31st March 2017

Anglia have been informed by the supplier Titan Opto that there has been a change to the mold for the parts which are listed below. The following pages detail the height change which has occurred to the part as a result of the new mold.

Part numbers affected by this notification:

SUG15D  
SUG15DT  
SUR15D  
SUR15DT  
SUR15DTB  
SUY15D  
SUY15DT  
SUY15DTB

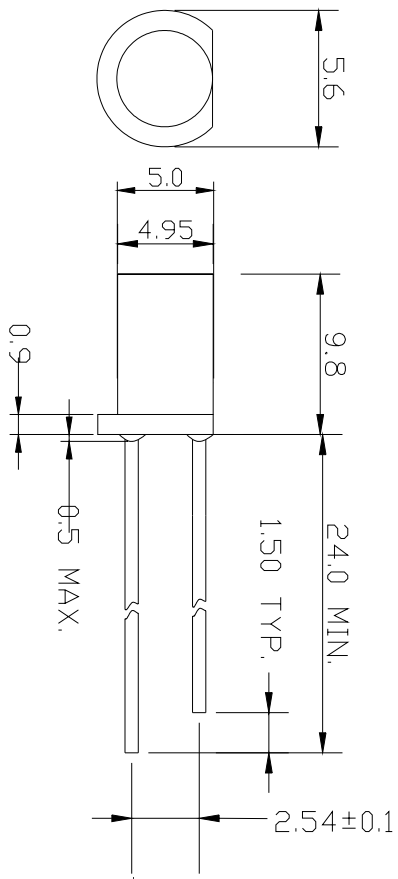
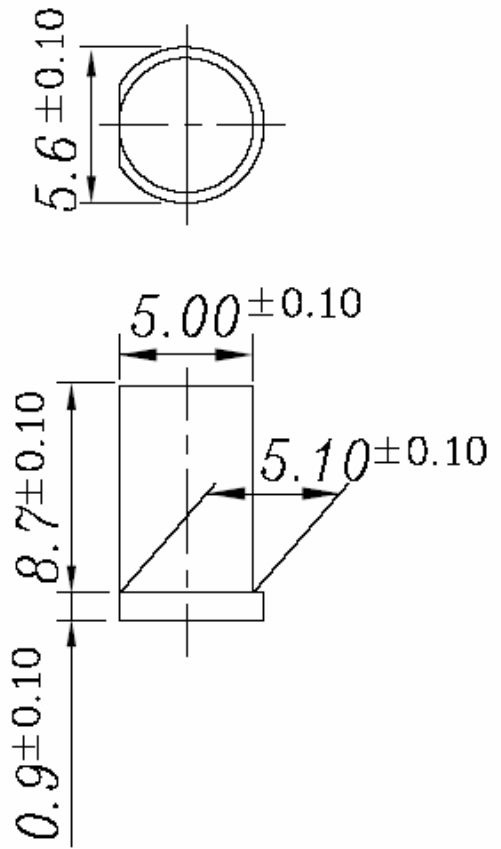
Spec 9.8mm  
Actual height 9.75mm  
Current

Spec 9.6mm  
Actual height 9.54mm  
New

Epoxy resin height : 9.8mm ( current )

9.6mm ( New )

difference : 0.2mm
